NEDO-31960-A  
Supplement 1  
Class I  
November 1995

Licensing Topical Report

# **BWR Owners' Group Long-Term Stability Solutions Licensing Methodology (Supplement 1)**

**APPENDIX A**  
**RESPONSE TO NRC QUESTIONS ON NEDO-31960**

Figure A.5. Comparison between equilibrium-cycle exclusion region and the exclusion region for the specific operating conditions of a BWR/S instability event.

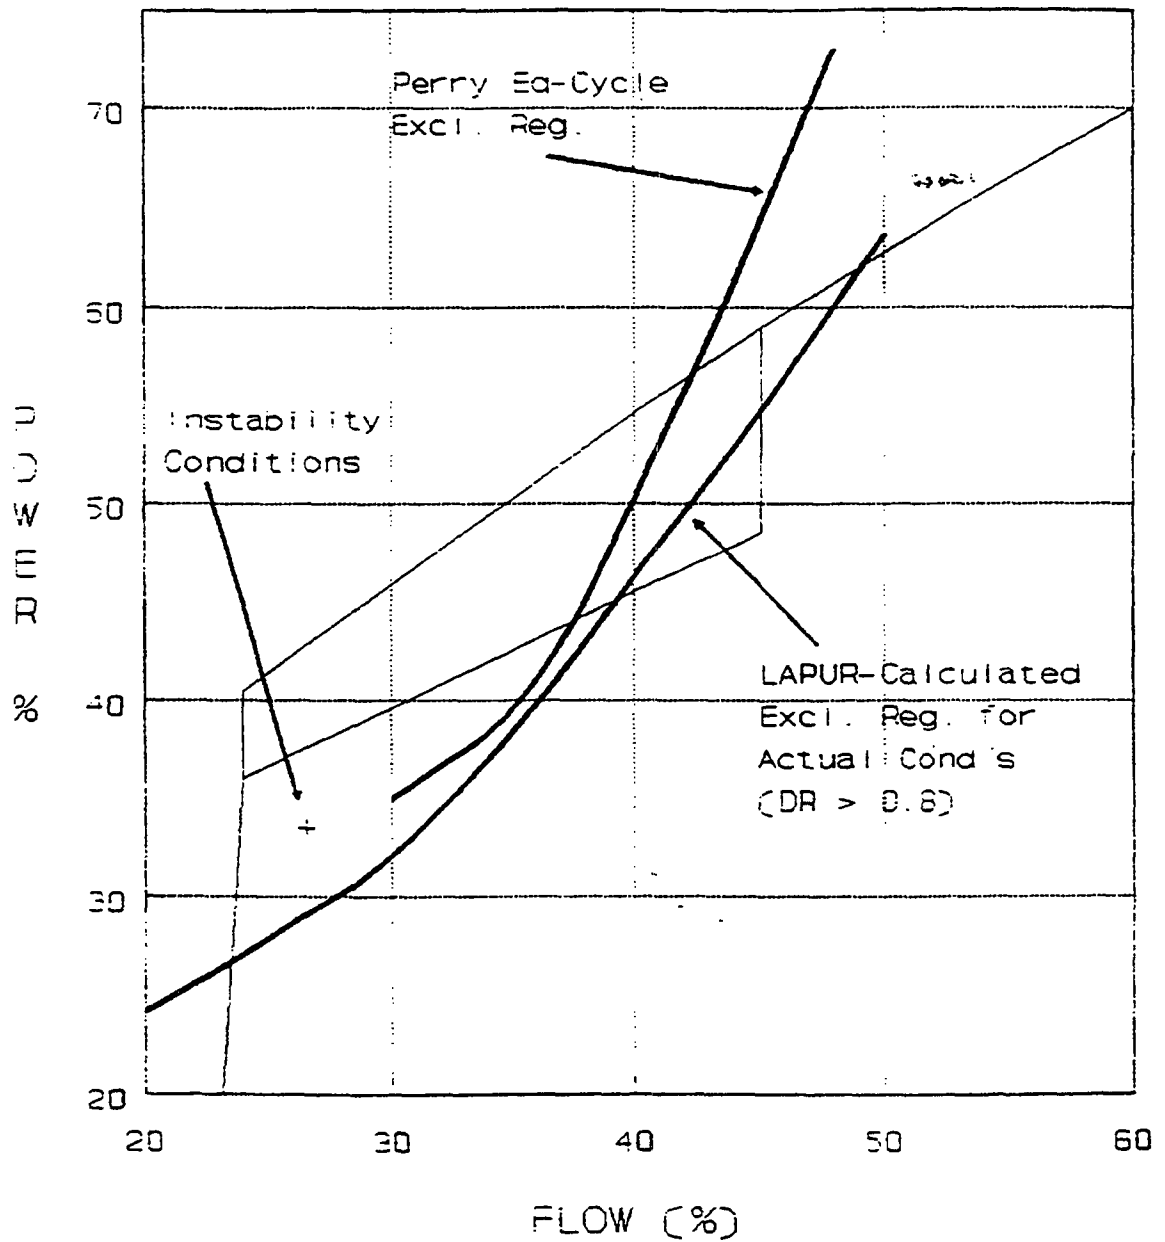
Figure A.5 shows a comparison of the equilibrium-cycle exclusion region for the Perry reactor (a BWR/6) and the exclusion region that results if the actual axial and power shapes from the recent BWR/5 event are used. As it can be observed, the standard BWR/6 exclusion region from NEDO-31960 is not as conservative as the actual region. Therefore, we have recommended that the BWROG must establish a criteria to limit the actual radial and axial peaking factors during startup operations to those values considered for the analyses of the exclusion region. This criteria must be based on parameters or information readily available to the operator in the control room.

Figure 5-1. FABLE/BYPSS Stability Criteria

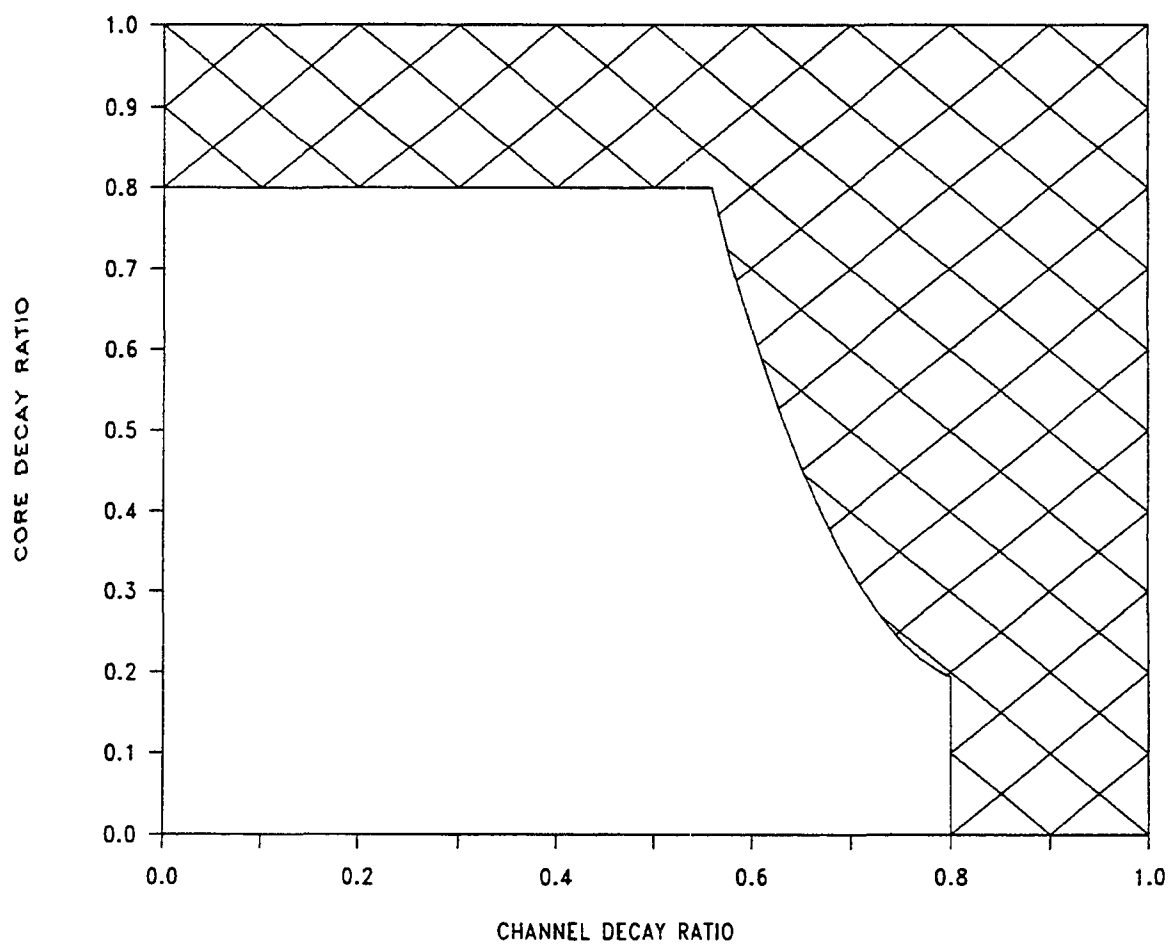
In Section 5.1, "Stability Criteria," a summary description of the acceptance criterion for stability calculations is described. This acceptance criterion is based on Figure 5-4 of NEDO-31960, which is a map of core and channel decay ratio where stability boundaries are defined for in-phase and out-of-phase instabilities. This map was developed with the aid of an unnamed "separate frequency domain code" following a procedure that is vaguely described in the document. The map of Figure 5-4 is the basis for all decay ratio calculations used for Solution I and for Solution III bypass settings. Thus, given its relevance to these results, the qualification of the code used and the procedure followed to define Figure 5-4 deserves more detailed description so that it can be reviewed properly.

In particular, describe which plant conditions were used in the validation, specifically answer whether the eigenvalue separation used for this qualification was bounding for expected operating plants. The curved part of the map should in theory be a function of the eigenvalue separation of the first subcritical mode; thus, specify whether a sufficiently reactive mode is used in the definition of the map of Figure 5-4."

Most of the results of these documents are based on decay ratio calculations that are compared to Figure 5-4. It would be convenient and easier to validate future calculations if Figure 5-4 were expressed in a unique mathematical form instead of in graphical form as it is now. A table of values for the curved part of the figure or a polynomial fit would uniquely define it and make acceptance of calculated decay ratio values an easier task."

The stability criteria shown in Figure 5-4 of Reference 1 (Figure 5-1 of this supplement), and further defined in Table 5-1 of this supplement to Reference 1, were developed based on a combination of post-test evaluations of instability events, theoretical considerations of regional oscillations, and the above-mentioned frequency domain calculations. Section 5.1 of this supplement provides additional details concerning the frequency domain code and the procedure used to estimate regional decay ratios using the code. Section 5.1 also discusses the conditions which were used in developing the stability criteria and concludes that the curved part of the map is representative of a sufficiently reactive harmonic mode.
